Our Ref: 112990/KW
Your Ref: Weldale Street, Reading

Re Weldale Street Reading, Application Number 220617

Many thanks for reviewing the Fairhurst Validation Report (112990, R9, April 2022). We are in receipt of the memorandum to Jonathan Markwell dated 10 May 2022 (ref EP/735289).

Original cover layer verification pit locations

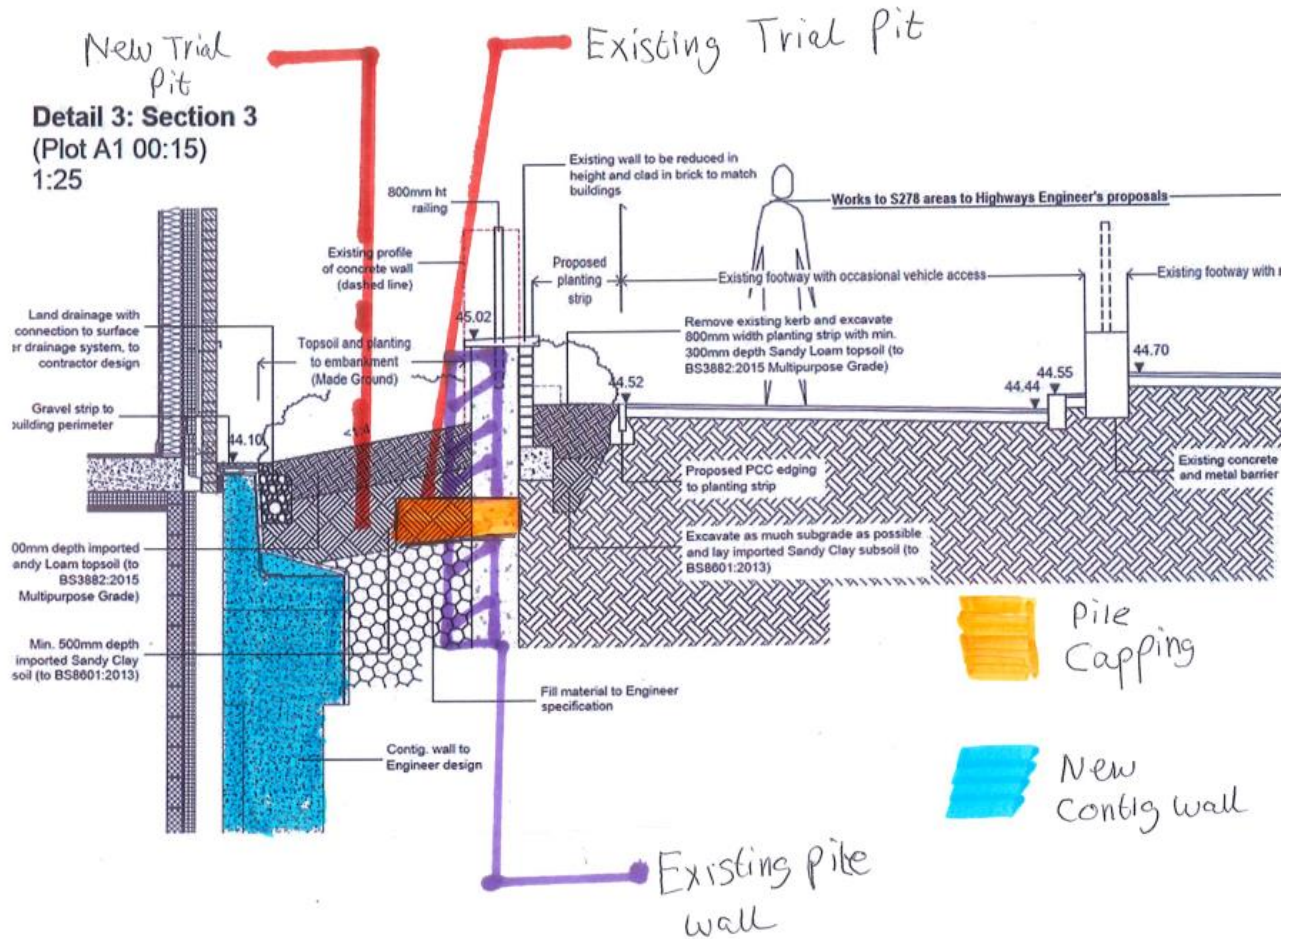
The trial pits excavated in the southern area of the site in squares B1 and C1 showed the specified thicknesses were not achieved. To add context, please see attached a cross section of this area of the site.

The original trial pits excavated by Fairhurst were located above the pile capping of the existing pile wall extending into the soft landscaped area. The required depth of excavation in these locations could not be achieved due to concrete piles and subsequently the topsoil/subsoil thicknesses were not achieved. Therefore, in this case, the pile cap acts as a barrier to human health, coupled with the presence of the orange geo-textile membrane, risks to the end users in these locations are mitigated.

Of the ten trial pits excavated across the site, three did not comply with the 450mm cover thickness specified (B1, B2 and C1). Two of these were as a consequence of the presence of an existing pile wall underlying the area (B1 and C1) and hence the structure provides a barrier beneath the capping layer. One location (B2) was re-dug near the original location away from

To demonstrate compliance with the strategy in the wider areas, the contractor has excavated three more trial pits in areas of B1, C1 and D1, please see the photographs appended to this letter. Trial pit location B2 encountered 300mm of topsoil over 150mm subsoil and locations C1 and D1 encountered 300mm topsoil over a minimum of 300mm subsoil. All three locations were underlain by the orange geotextile membrane.

A trial pit was excavated near the original location within square B2 and demonstrates compliance with the Remediation Strategy. Some variation in cover layer thicknesses can be expected throughout site partially due to the location of services, as was the case here, and partially due to settlement. The second trial pit excavated by the Contractor within this area showed 300mm topsoil over 150mm subsoil and 150mm reject stone underlain by the orange geo-textile membrane.
